SUBJECT: REQUEST FOR ADDITIONAL INFORMATION REGARDING APPROVAL TO
ADD NUHOMS®-32PT DRY STORAGE CANISTER TO THE STANDARDIZED
NUHOMS® SYSTEM (TAC NO. L23343)

**TRANSNUCLEAR, INC.
DOCKET NO. 72-1004
TAC NO. L23343**

REQUEST FOR ADDITIONAL INFORMATION

Figure 1. Illustration of parallel paths $k_{eff-along}$ assumed in TN's ANSYS® model for the basket and associated components

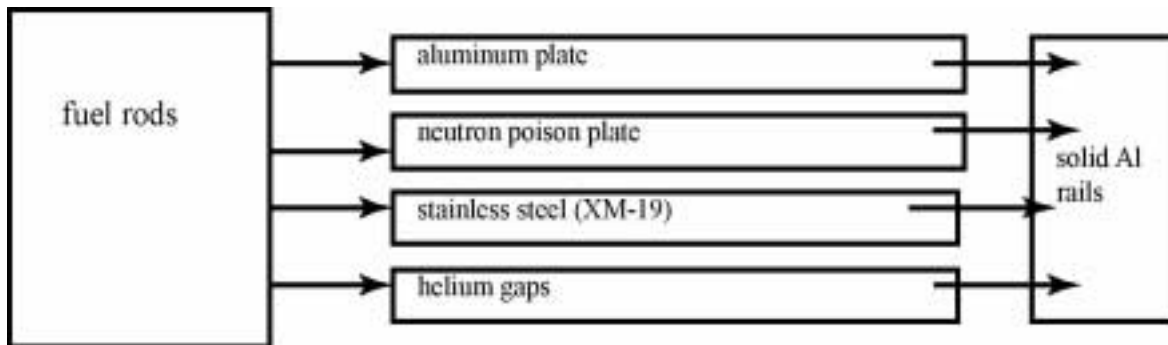
The TN NUHOMS®-32PT ANSYS® model utilizes an effective conductivity for heat transfer from the fuel rods through the basket and associated components (i.e., the L-shaped aluminum plates and neutron poison plates lining the basket, and the stainless steel plates comprising the basket.) This effective conductivity is defined using a parallel-path (along the layers) algorithm of the functional form,

This approach can be used to represent the heat flow path along the layers and along the length of the canister (although in this direction these components do not connect directly to the support rails). However, axial heat transfer is capable of removing only a small part of the heat from the canister. This is by design; the structure of the storage module in which the canister sits requires that the canister design allow the bulk of the heat to be removed through the sides of the canister. This means that most of the heat transfer is in the radial direction.

1. Revise the thermal model of the NUHOMS®-32PT DSC to take into account the orthotropic nature of the basket materials, including the helium, aluminum, and neutron poison materials. The thermal conductivity of the basket materials will not be the same across the aluminum and neutron poison plates (serial path) as it would be along the aluminum and neutron poison plates (parallel path).
2. If, after the revision to the thermal model as described above is complete, fuel cladding temperatures are above the applicable limits, provide an alternative path for certification of the NUHOMS®-32PT DSC.

Figure 2. Conceptual diagram of radial heat flow through the basket region

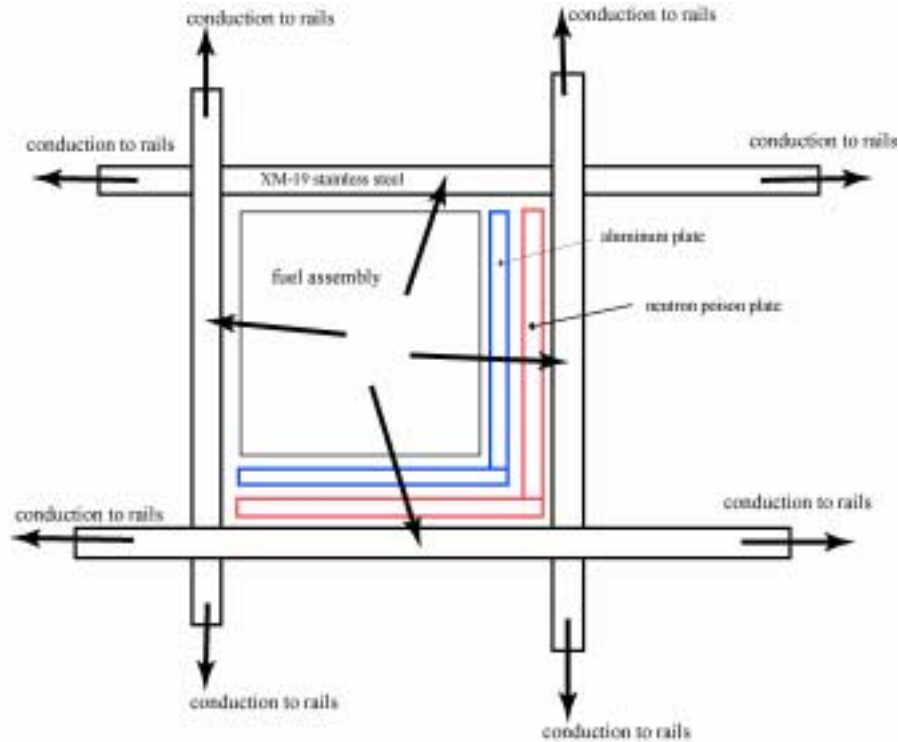
Figure 2 is a conceptual representation of these radial heat transfer paths through the basket. In no case can the heat flow be treated as following a parallel path (along the layers) exclusively, as described by the equation above. The effect of using a $k_{\text{eff-along}}$ as defined as in the above equation for radial heat transfer through the basket, results in a significant overestimation of the effective thermal conductivity of the basket structure.

In this case, for the direction passing through the right or lower wall of the “cell” depicted in Figure 2, the applied effective thermal conductivity ($k_{\text{eff-along}}$) works out to be a little more than four times that which should have been applied ($k_{\text{eff-through}}$) as illustrated by the following calculation.

Inserting appropriate values for these thermal conductivities and using the specified dimensions of the various components yields a value for $k_{eff-along}$ that works out to be approximately 4.3 to 4.7 times larger than $k_{eff-through}$.

A value of $k_{eff-along}$ was applied in all directions in the ANSYS® model supplied by TN, to define the effective thermal conductivity in the bodies representing the basket region. The different materials in the basket region were not modeled in ANSYS® with separate material orientation (orthotropic) and property definitions for aluminum, neutron poison, stainless steel, or gaps. Instead, the entire structure of the basket was represented as a 'uniform' material in which all bodies had the same effective thermal conductivity, calculated in the manner described above for $k_{eff-along}$. Hence, the same value of $k_{eff-along}$ was applied in both the "along" and "through" directions. This is an incorrect approach as heat transfer must pass serially through the aluminum and neutron plates and associated gas gaps and then into and through the stainless steel to reach the support rails.
